## ARAMCO SERVICES JSP14-21

Approval of the request of Kirco Manix Construction for Preliminary Site Plan. The applicant is proposing to construct a new 75-space parking lot expansion to the east of the existing Aramco Services building, construct a new hazard materials storage building and tanks in the existing enclosure, and construct a screened explosion relief area in the existing building. The property is located at the northeast corner of Hudson Drive and Peary Court in the Beck North Corporate Park.

# PLAN REVIEW CENTER REPORT

## Engineering Review Aramco Parking Lot Expansion

Client information table including: Client: ACS 3330 UNIVERSITY AVE, SUITE 200 MADISON, WISCONSIN 53705-2167; Project Name: ARAMCO RESEARCH & DEVELOPMENT CENTER; Project No: 1412; Date Issued: 04/21/14; Sheet: SP-1.

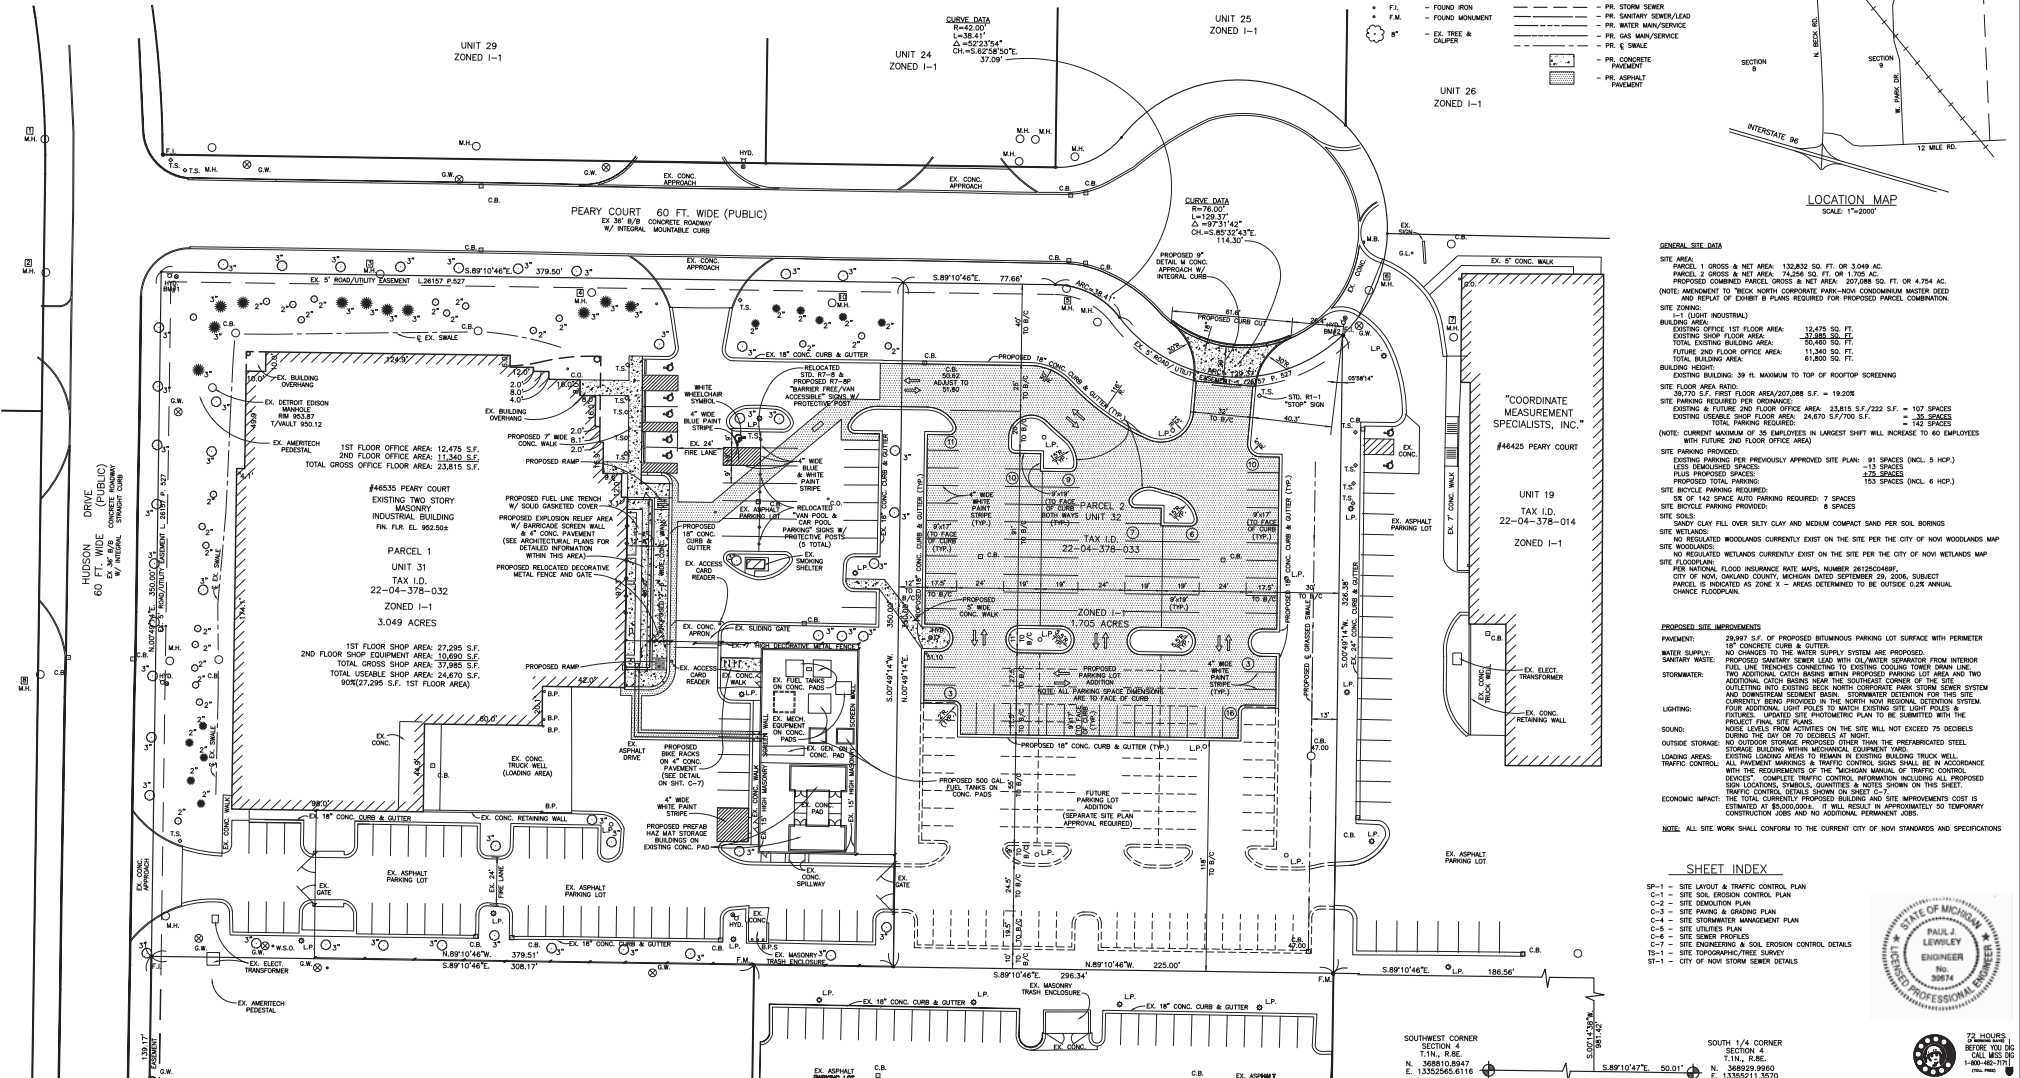
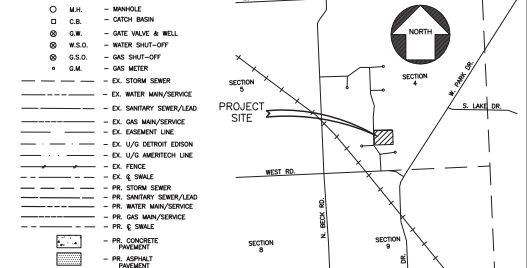
2. To meet the ADA requirement for barrier-free spaces, two existing mid-lot spaces nearer the building would be converted to one, 9-ft-wide barrier-free space and one, 9-ft-wide access aisle, resulting in a net loss of one parking space in this part of the lot. Six parking spaces are to be removed along the building's east façade, and another four spaces will be lost in providing the connection between the new and existing lots. **It appears that a total of 11 existing parking spaces will be "demolished," not 12 as claimed under General Site Data on sheet SP-1; this needs to be checked and corrected as necessary.**

4. No. The proposed new access drive on the cul-de-sac bulb would be only 29 ft from the existing drive to the northeast (near-back-of-curb to near-back-of-curb). Design and Construction Standards Sec 11-216(d) requires a minimum same-side driveway spacing of 105 ft for a “road speed” of 25 mph (the prima facie speed limit on Peary Court). **A same-side driveway spacing waiver by the Planning Commission is therefore required.**

6. No. Given the site’s I-1 zoning, the new access drive must be at least 32 ft wide (back-to-back at the interior ends of the tapers), per DCS Fig IX.1 (the standard is 36 ft, but 32 ft has been approved elsewhere in Beck North). The proposed drive is dimensioned 30 ft wide but scales 31 ft wide. **The drive width must be revised to be both drawn and dimensioned 32 ft wide.**
7. **The size of the proposed new STOP sign has not been specified but should be listed under Proposed Traffic Sign Quantities (on sheet SP-1) as 24” x 24”** (the size in place at the other site drive on Peary Court).

- 5.) The proposed drive approach has been widened to 32 feet and dimensioned accordingly on Sheet SP-1 as requested in the traffic review. A Type M approach curb opening is now specified on Sheet C-3 with a corresponding detail added on Sheet C-7.

- 2.) The total of 11 existing parking spaces to be "demolished" has now been increased to 13 spaces to provide better access at the southwest corner of the screened equipment yard.
- 4.) The requirement for a Planning Commission same side driveway spacing waiver is acknowledged.
- 6.) As previously mentioned, the proposed drive approach has been widened to 32 feet and dimensioned accordingly on Sheet SP-1.
- 7.) The proposed stop sign is now listed as 24"x24" in the traffic sign quantities on Sheet SP-1.
- 10.) The typical parking space dimension notes on Sheet SP-1 now stipulate these dimensions are to the face of curb.
- 12.) The Standard Parking Island Detail has been removed from Sheet C-7. The requested striping notes have been added on Sheet SP-1.
- 13.) The typical Handicap Parking Signs Detail on Sheet C-7 has been revised as requested.
